# Access Compliance Report

## Public Rights-of-Way

Intersection ID: 24902	Main Street: CHOATE_CR	Cross Street: JOHN_BECK_DR	Location: SE
ADA ID: 20CB612FF711	Ramp Type: BlendTrans2	Initial Pass/Fail: Fail	Overall Compliance: No
		Severity Score: 12.5

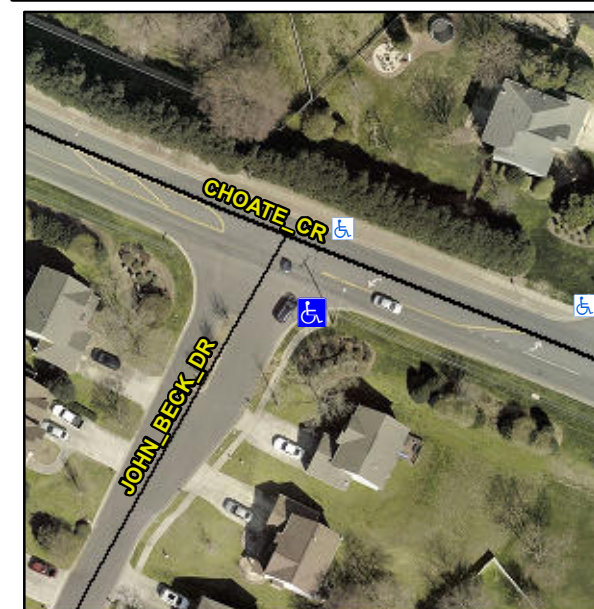
Compliance	Description	Data	Compliance	Description	Data
N/A	Ramp Length (in)	96.0	Yes	BlendTrans Slope (%)	0.7
Yes	Ramp Width (in)	48.0	No	BlendTrans XSlope (%)	6.1
N/A	Flare Type LT	N/A	N/A	Flare Type RT	N/A
N/A	Flare Slope LT (%)	N/A	N/A	Flare Slope RT (%)	N/A
N/A	Flare Traversable LT?	N/A	N/A	Flare Traversable RT?	N/A
N/A	Landing Length (in)	N/A	N/A	DWS Provided?	N/A
N/A	Landing Width (in)	N/A	N/A	DWS Contrast?	N/A
N/A	Landing Slope (%)	N/A	N/A	DWS Length (in)	N/A
N/A	Landing X Slope (%)	N/A	N/A	DWS Full Width?	N/A
N/A	Landing Curb? (Y/N)	N/A	N/A	DWS Offset (in)	N/A
N/A	Shared Landing?	N/A			
N/A	Gutter Ponding?	N/A	N/A	Gutter Slope (%)	N/A
N/A	Gutter Lip Ht (in)	N/A	N/A	Gutter X Slope (%)	N/A
N/A	Painted X Walk1?	No	N/A	Painted X Walk2?	No
	X Walk 1 Direction	To NE		X Walk 2 Direction	To NW
	X Walk 1 Width (in)	N/A		X Walk 2 Width (in)	N/A
	X Walk 1 Slope (%)	9.3		X Walk 2 Slope (%)	0.7
	X Walk 1 X Slope (%)	1.4		X Walk 2 X Slope (%)	7.7

**Remove & Replace Curb Ramp With Two New Directional Ramps or Equivalent.**

**R304.5.3**
